September 24, 1984

Joseph M. Farley Nuclear Plant - Units 1 and 2
Proposed Administrative Technical Specification Change

Attached is revised Technical Specification Figure 6.2-2 for Units 1 and 2 to reflect the above clarification. This clarification is a non-substantive change to the June 25, 1984 proposed technical specification change. The necessary changes to the FSAR have been initiated, pursuant to 10CFR50.59, to reflect the proposed technical specification change and this clarification. The appropriate procedures will be modified to indicate this clarification of operation responsibilities after receipt of the approved license amendment.

Figure 6.2-2 Facility Organization

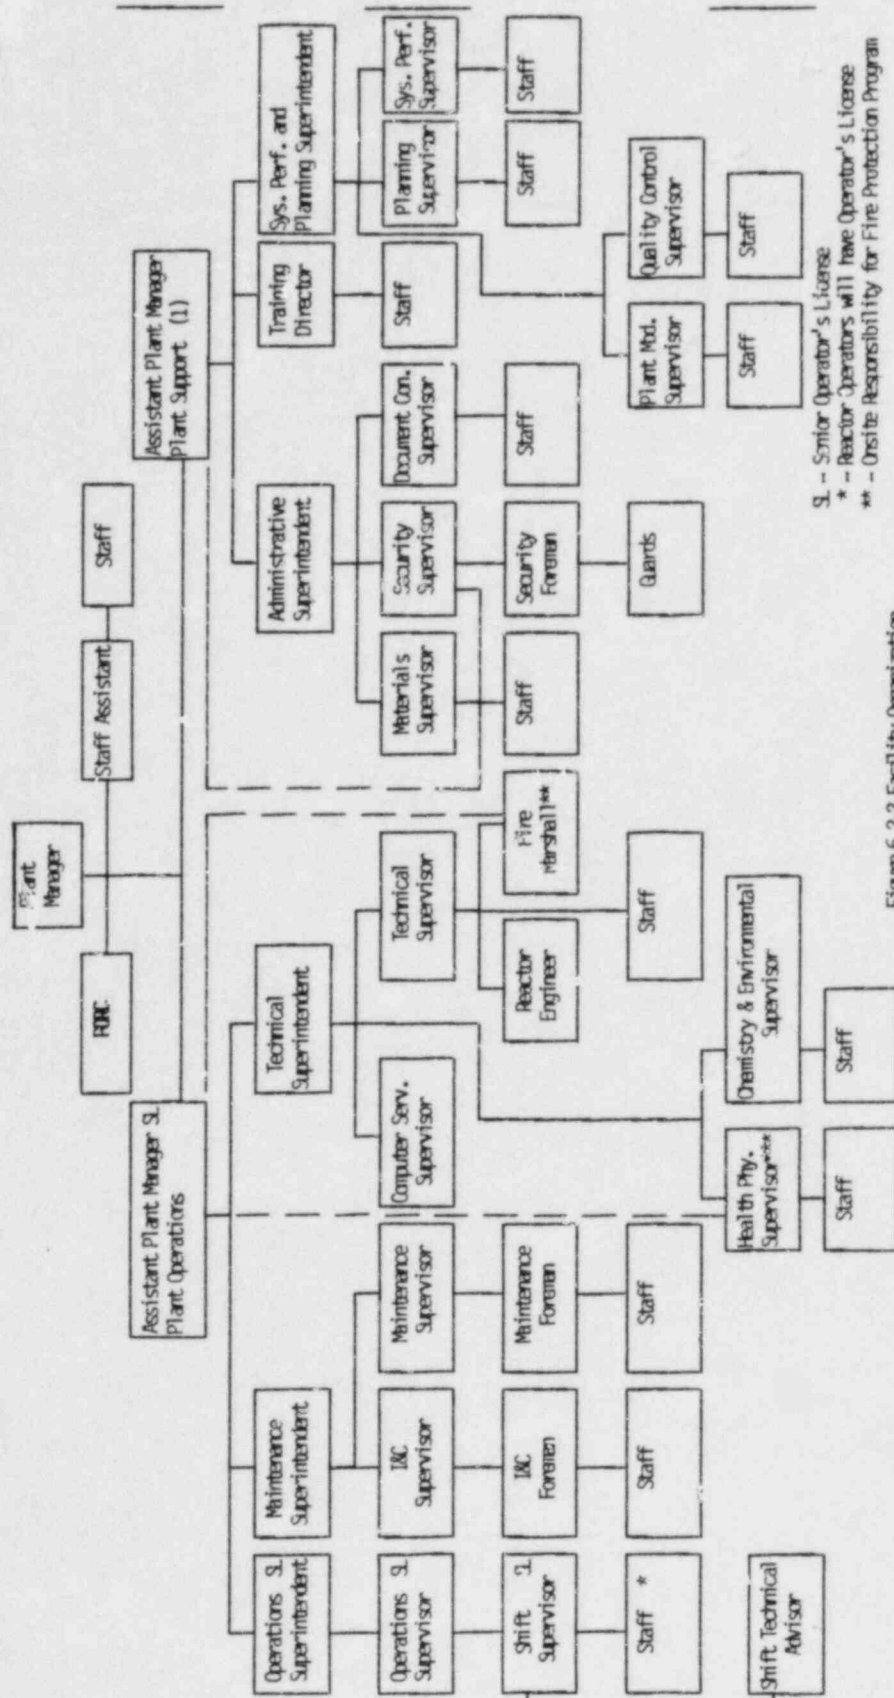
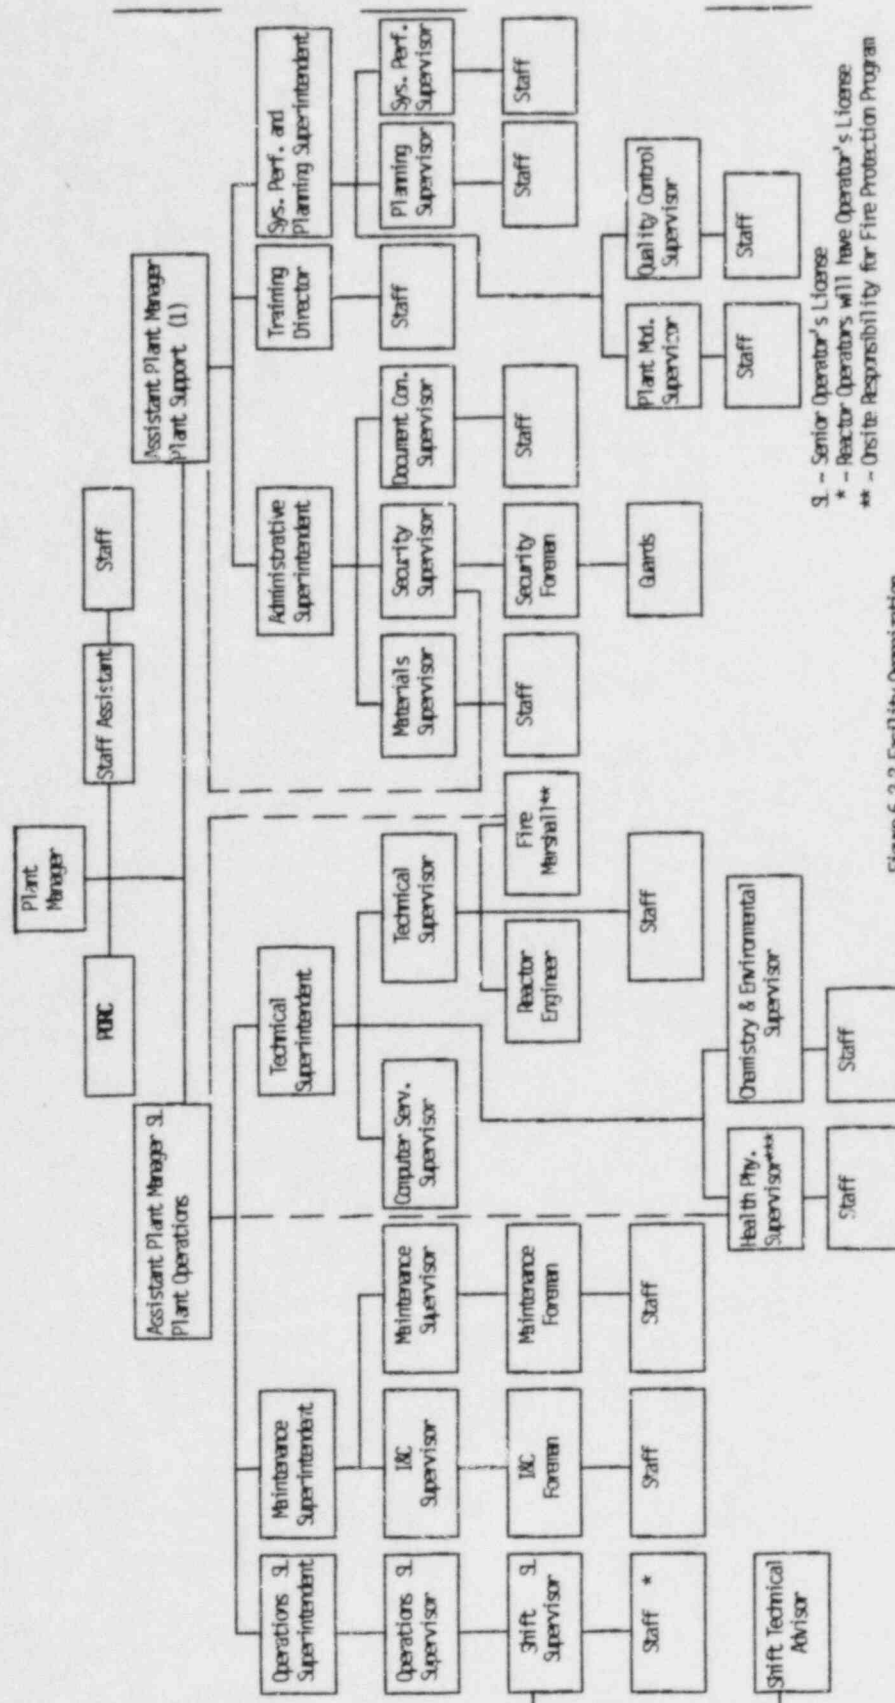
The Assistant Plant Manager, Plant Support position has been established with the recognition that in the absence of the Plant Manager, the Assistant Plant Manager, Plant Support may occasionally be delegated the Plant Manager's responsibilities. This means that prior to being delegated these responsibilities, the Assistant Plant Manager, Plant Support will be fully qualified to fulfill the responsibilities of the Plant Manager per ANSI N18.1-1971 and FSAR 13.1.3.1.1 with the added stipulation that Emergency Director Training has been completed.

(1) The person filling this position may act as the Plant Manager, provided this person meets the requirements of ANSI N18.1-1971 Section 4.2.1, FSAR Section 13.1.3.1.1 and has completed Emergency Director Training.

(1) The person filling this position may act as the Plant Manager, provided this person meets the requirements of ANSI N18.1-1971 Section 4.2.1, FSAR Section 13.1.3.1.1 and has completed Emergency Director Training.
